CN20006: RTG4 Family Important Changes

April 22, 2020

This document describes the following three changes to the RTG4 product family.

Figure 1 • RTG4 Programming Options GUI

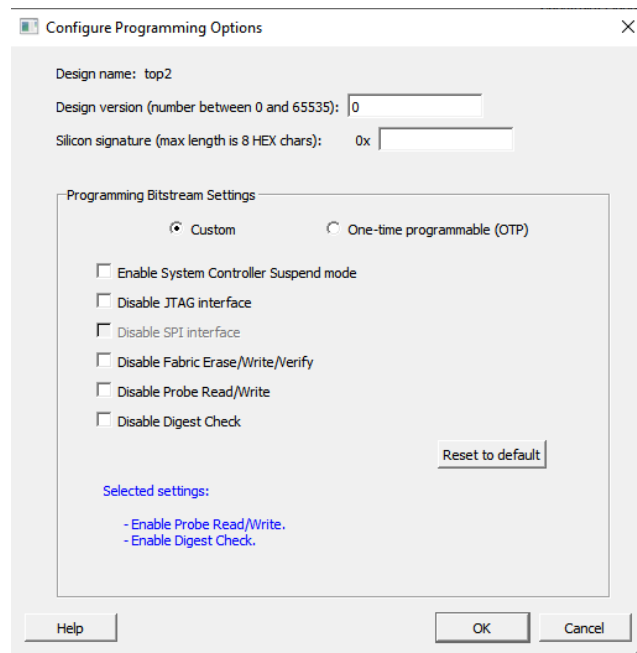
In Libero SoC v12.0 to v12.3, using the configuration tool to “Configure I/O States During JTAG Programming” can cause a loss of user programming settings selected via “Configure Programming Options”, “Configure Action/Procedure” for the “Run Programming Action” step, and “Generate Bitstream” options.

When operating an RTG4 device, if System Controller Suspend mode is selected, this issue could permanently prevent the device from exiting System Controller Suspend mode, and permanently lose the capability of reprogramming the device. We recommend upgrading to Libero SoC v12.4.

- If System Controller Suspend Mode (SCSM) is enabled (which automatically disables the JTAG interface), the bitstream generated after configuring I/O states during programming can prevent all further JTAG access, and thus permanently prevent further device programming with Scan Chain failure and "TDO stuck at {0,1}" msg.

- If Fabric Erase/Write/Verify is disabled, the bitstream generated after configuring I/O states during programming can permanently prevent further JTAG programming with the “Operation has been disabled by programming bitstream settings” message.

- For RTG4, this issue only occurs if running “Configure I/O States During JTAG Programming” in Graphical User Interface (GUI) mode.
- There is no issue if the “Configure I/O States During JTAG Programming” GUI is not used, no issues in Tcl scripted mode.

Do not program any further RTG4 devices with programming files (Libero SoC v12.0 to v12.3) using I/O states during programming GUI combined with the programming options listed above. Upgrade to Libero SoC v12.4, observe that all "Generate" and "Export" programming steps in the design flow will be invalidated, then re-run I/O States GUI and re-configure Programming/Bitstream options prior to Generating and Exporting new bitstreams.
